February 16, 2010

Stakeholder Correspondence–California Energy Commission

*Subject:* **Comments on the Mariposa Energy Project (09-AFC-03)  
United States Army Corps of Engineers Wetland Delineation Amendment for the  
Mariposa Energy Project – Field Verification Including the  
Alternative Water Supply Pipeline Route**  
Chevron Environmental Management Company  
Historical Pipeline Portfolio–Bakersfield to Richmond

Figure 1. Historical Pipeline Alignments – Mariposa Energy Project

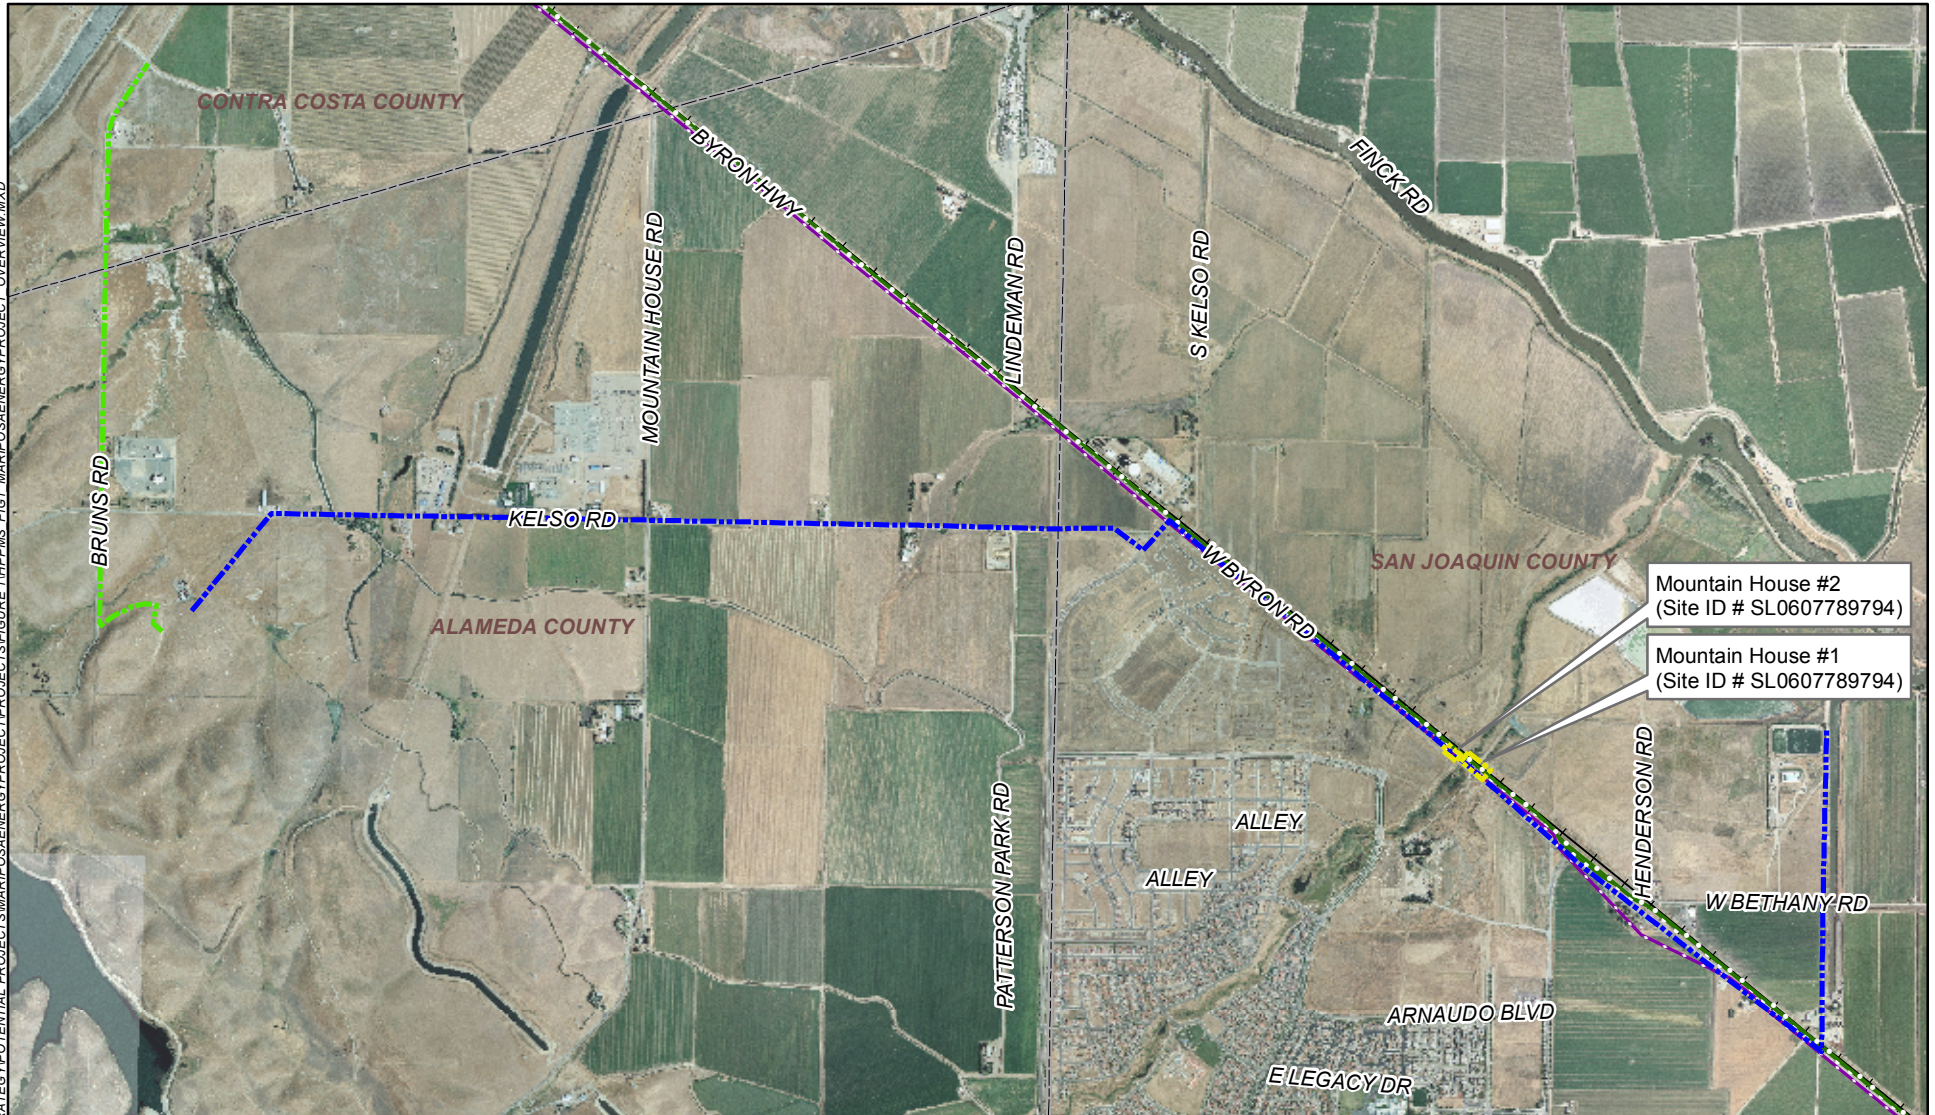
Figure 1 illustrates the area where the proposed AWSP will coincide with the former OVP and TAOC ROWs. The proposed AWSP route transects two former CEMC investigation sites where releases related to the former OVP and TAOC pipelines have been documented. Please visit the California State Water Resources Control Board Geotracker website at <http://geotracker.swrcb.ca.gov/> for more information regarding the following sites:

CEMC recommends that the project proponent be prepared to address residual weathered crude oil, pipelines, and ACM from the former OVP and/or TAOC systems during subsurface construction activity. This potentiality is easily managed with some advanced planning. CEMC would appreciate being informed of progress regarding the proposed project, any encountered petroleum, pipelines, and pipeline-related ACM, and any additional planned construction and land development projects in the vicinity of the former OVP and TAOC ROWs.
